Trinity Islands Site C, Manchester

Non-Material Amendment | 21.01.2026

ZC-SHP-A180-RP-XX-NMA01 | P01

4.1 - Quantum // Proposed Apartment Mix/Parking Numbers

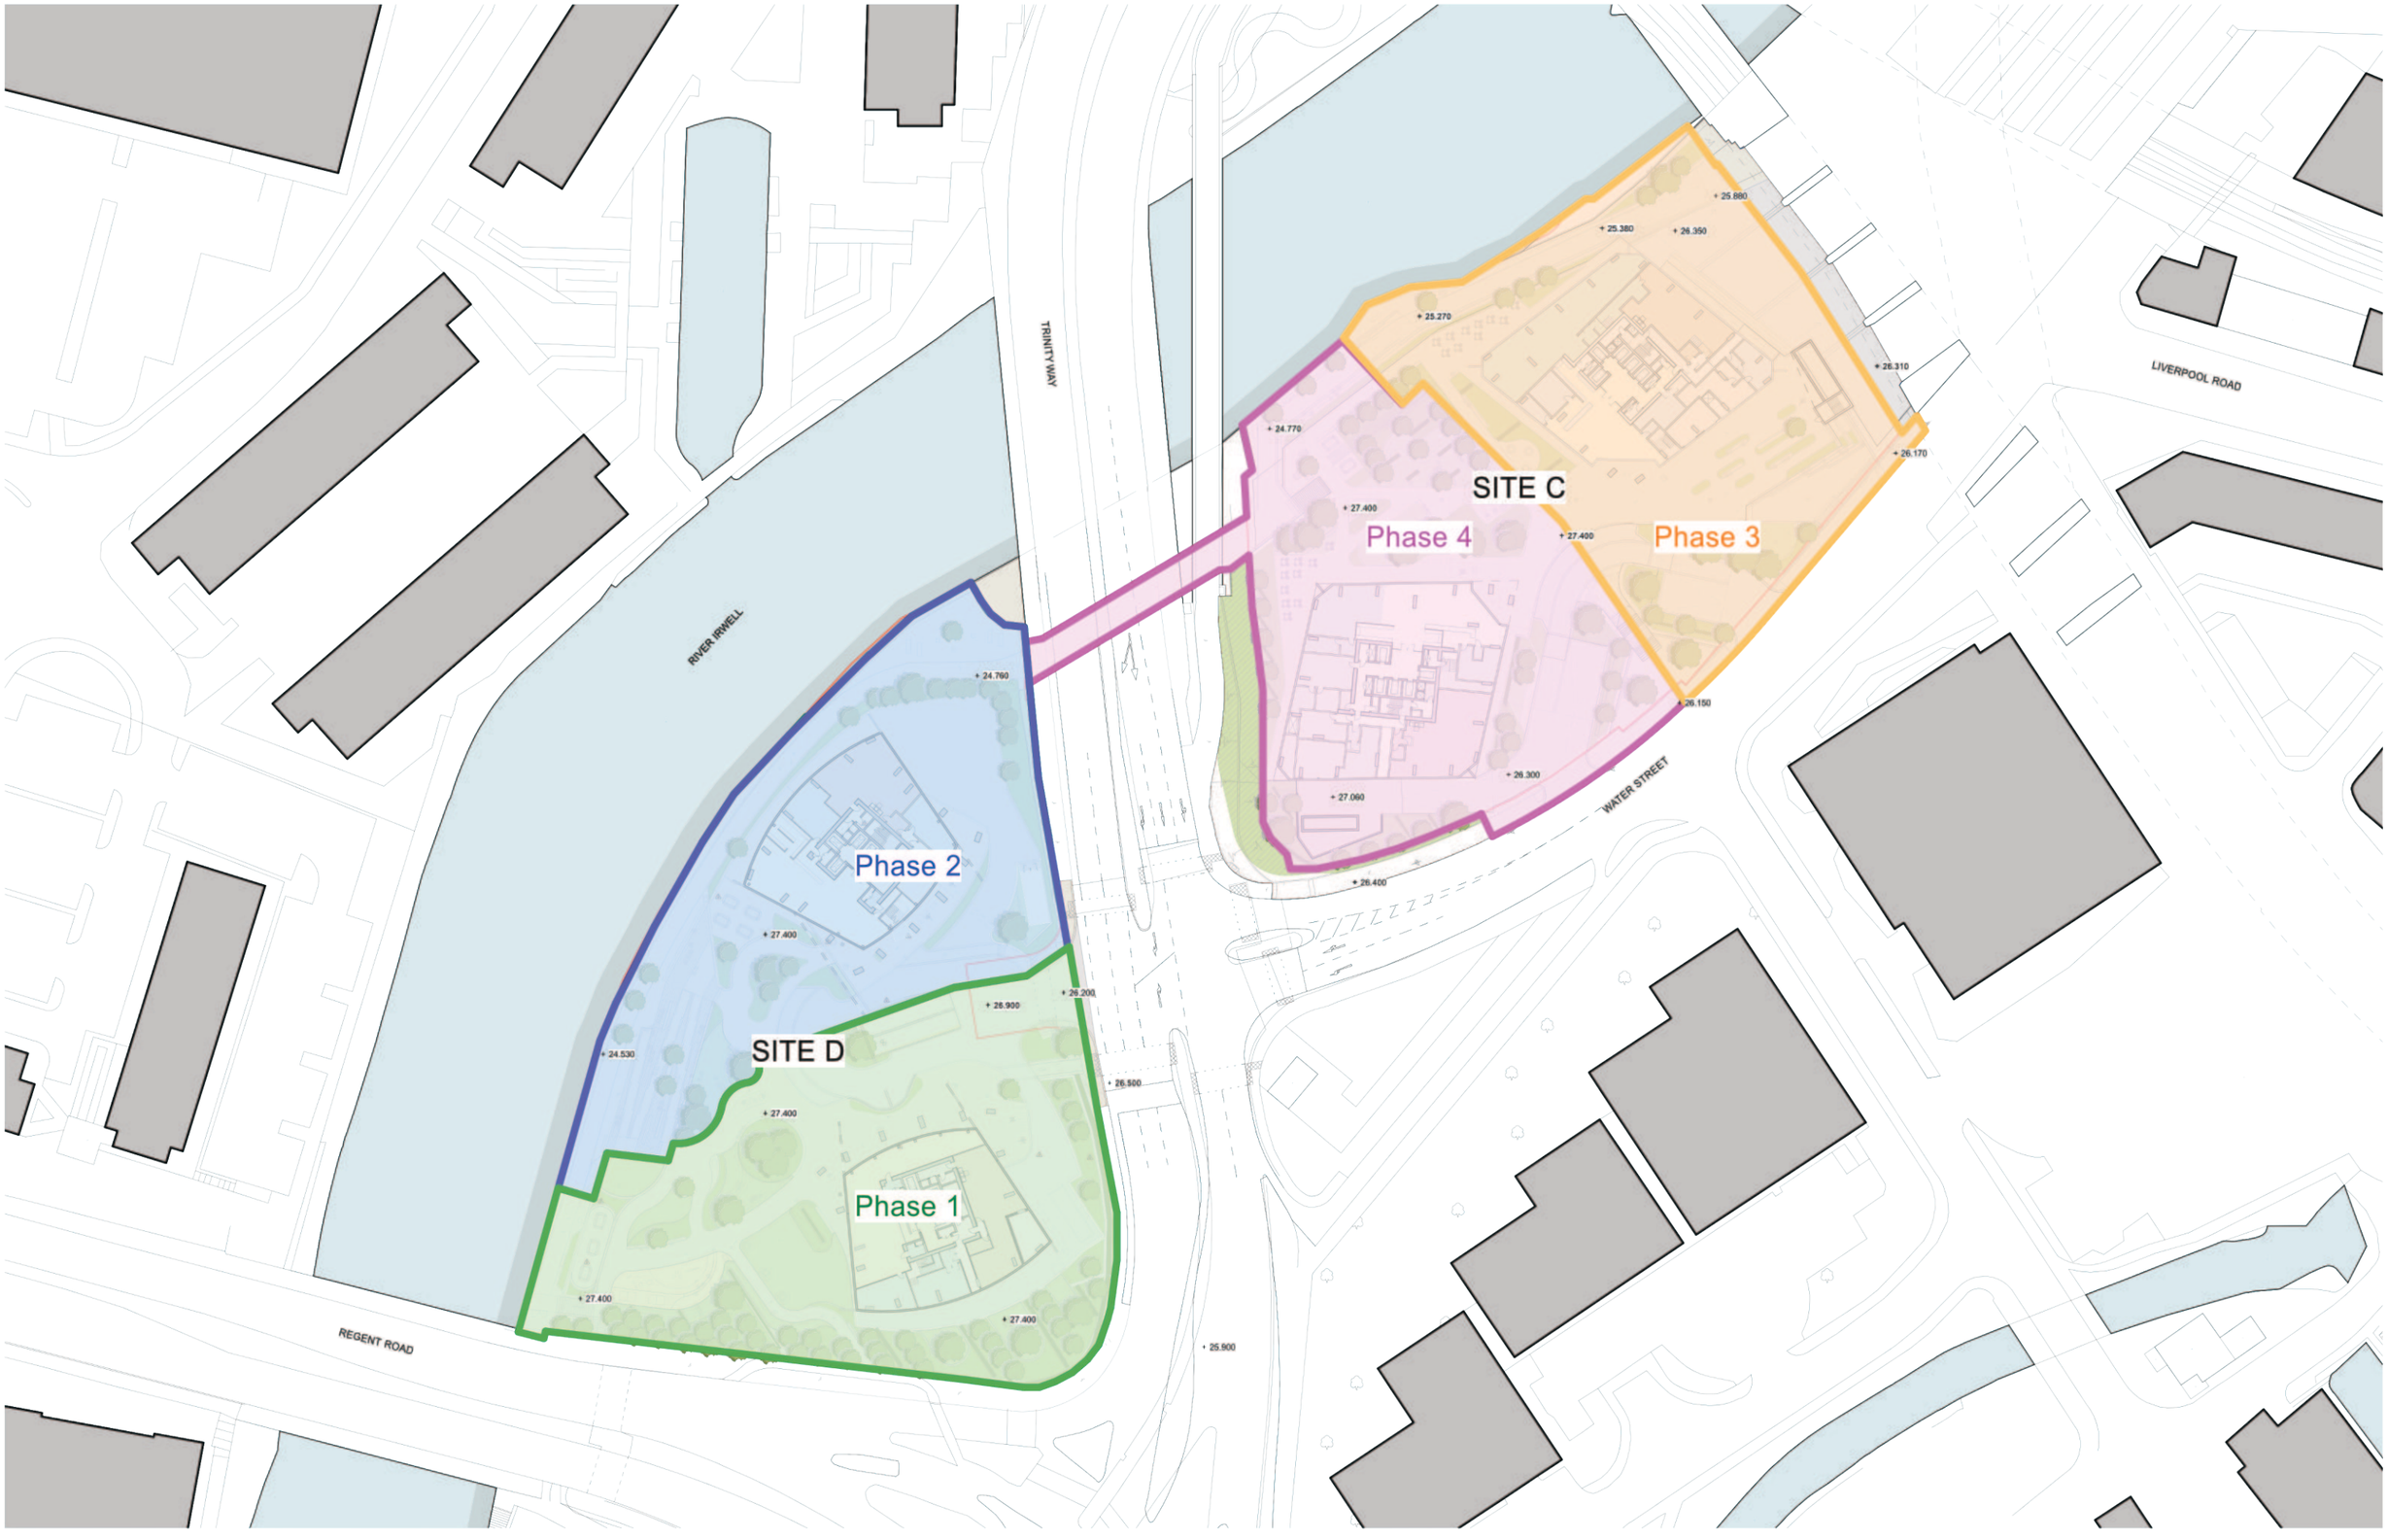
1. Slight amendment to mix of apartment types; slight reduction in total parking provision.

Total Car Parking Spaces	117	255 PARKING SPACES TOTAL
Electric Vehicle Charging	20% @ 7kW*	
Accessible Spaces	10%	
Cycle spaces	414

Total Car Parking Spaces	138	
Electric Vehicle Charging	20% @ 7kW*	Note. 10% of the electric spaces to be fitted with a 10% future proof provision
Accessible Spaces	10%	
Cycle spaces	521

4.2 - Boundary // Proposed Phasing Plan

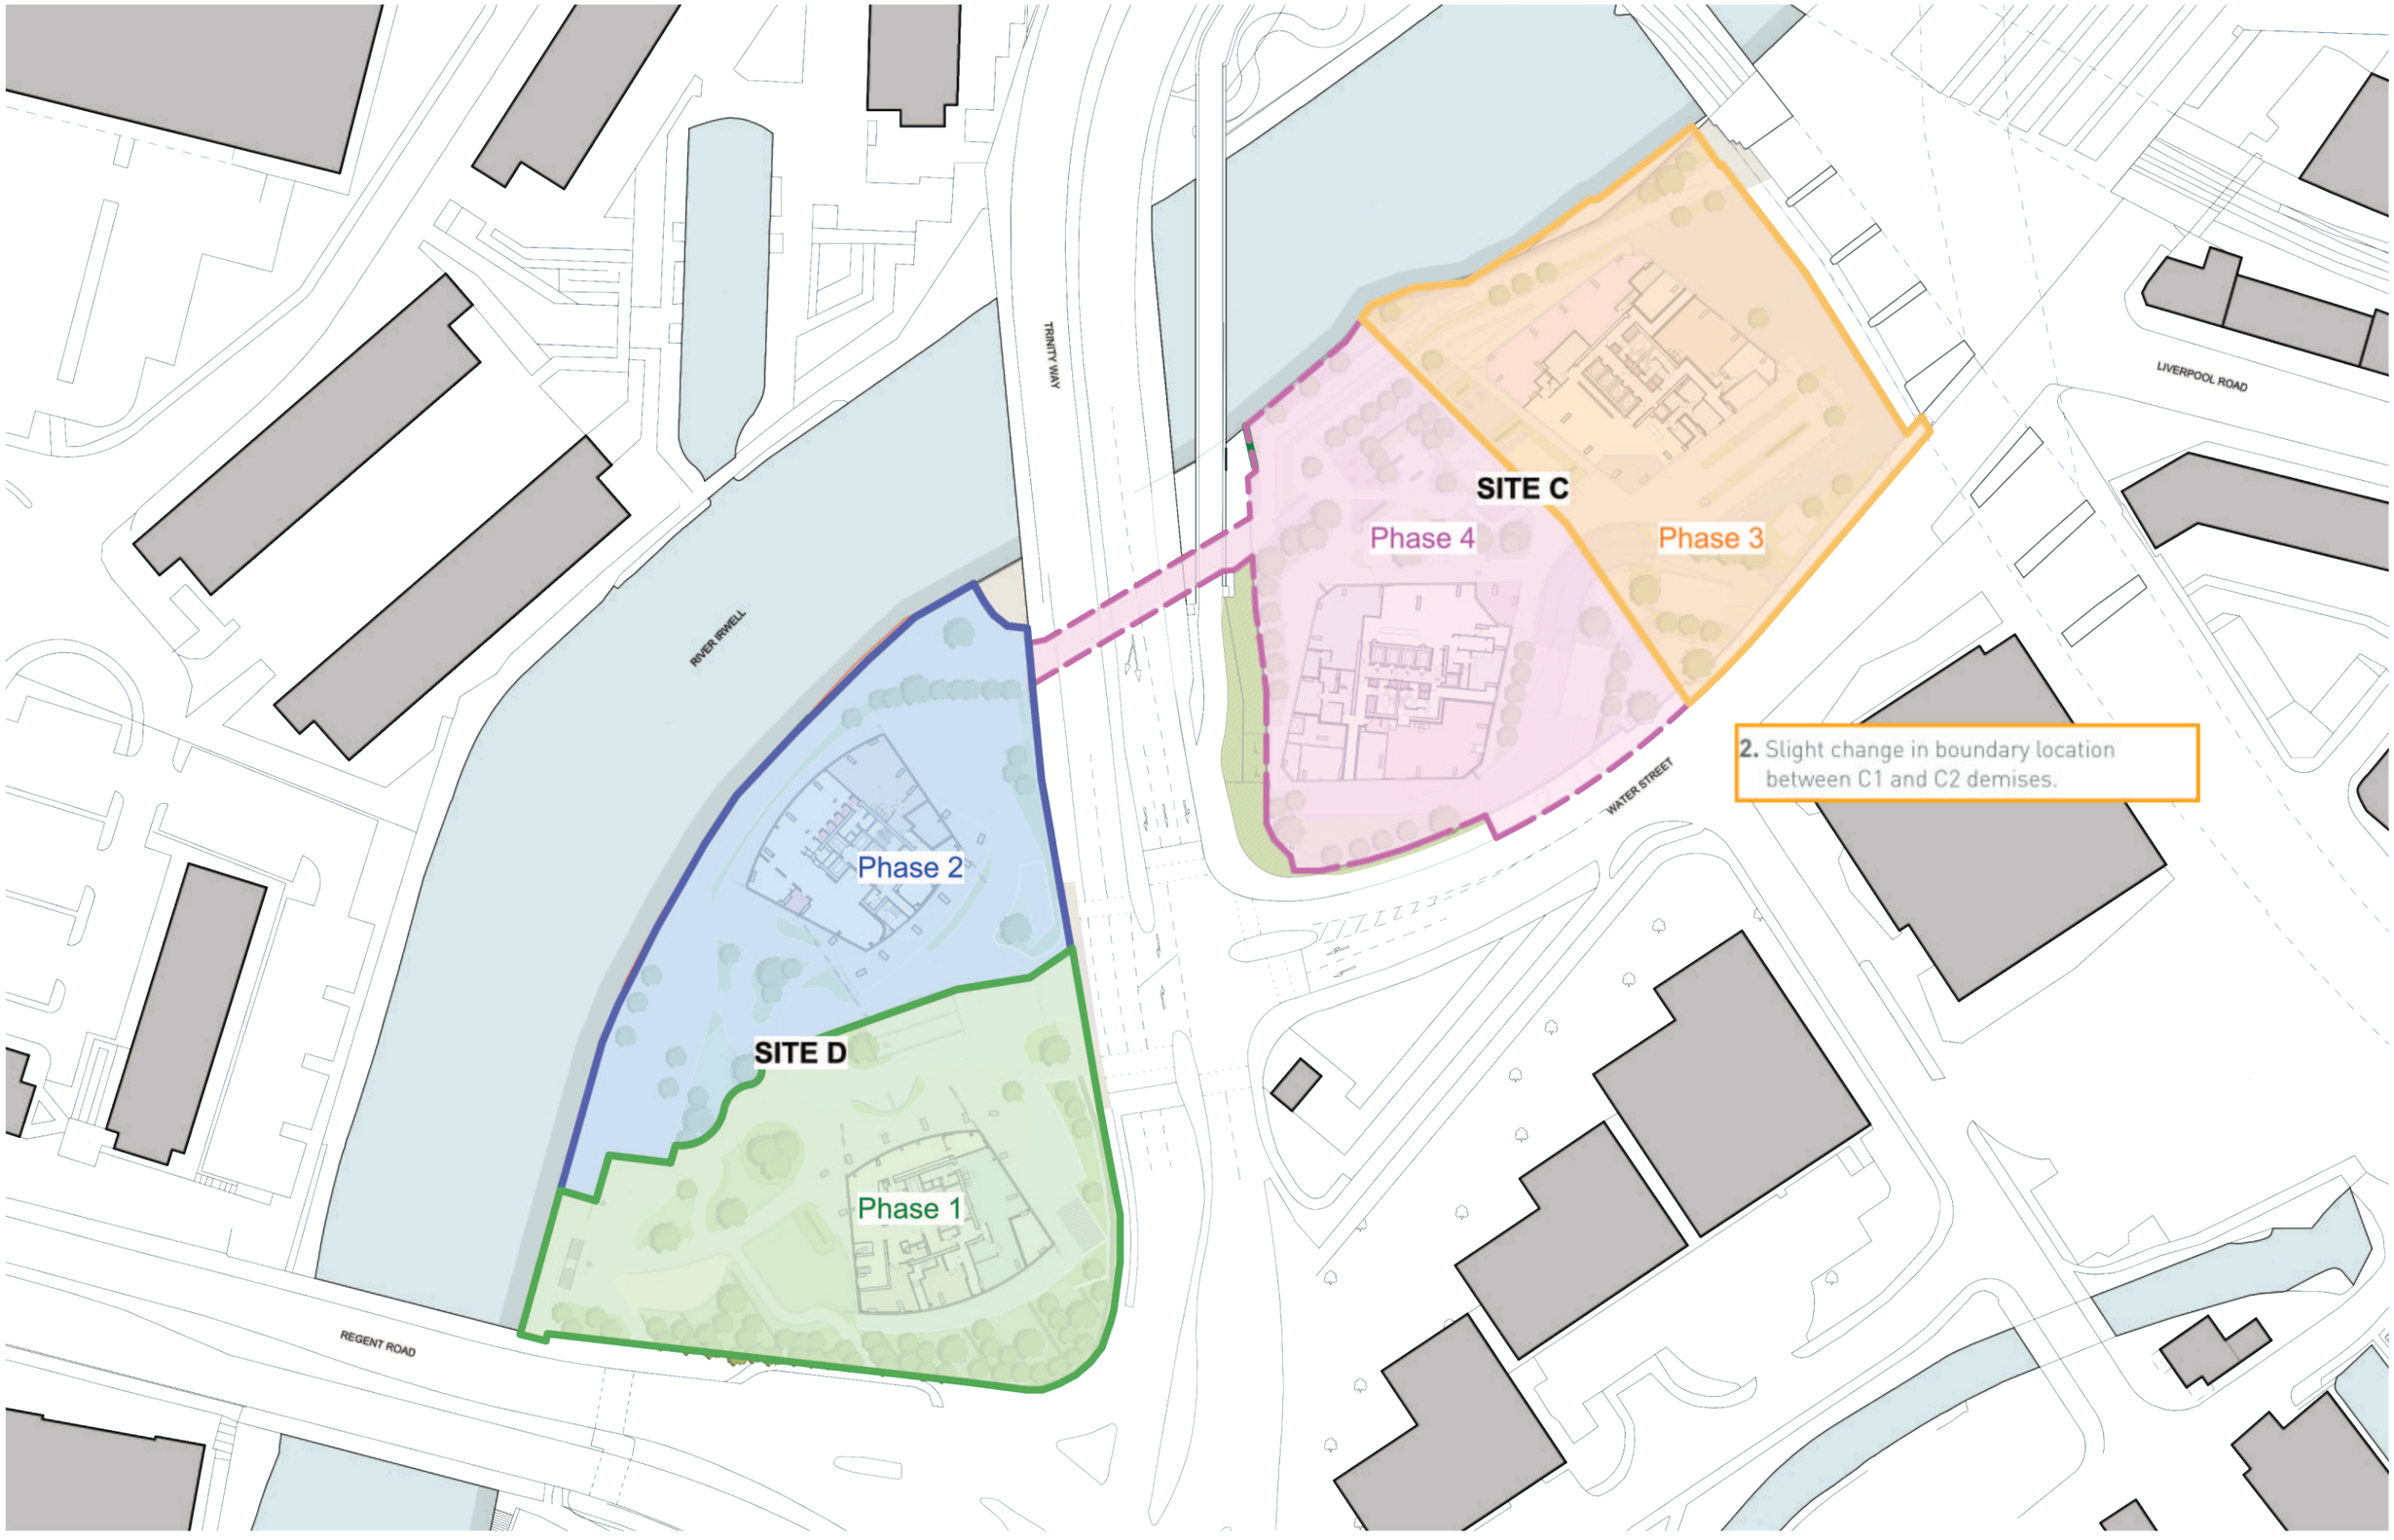
1. **Qantum**
   Slight amendment to mix of apartment types; slight reduction in total parking provision.
2. **Bundary**
   Slight change in boundary location between C1 and C2 demises.
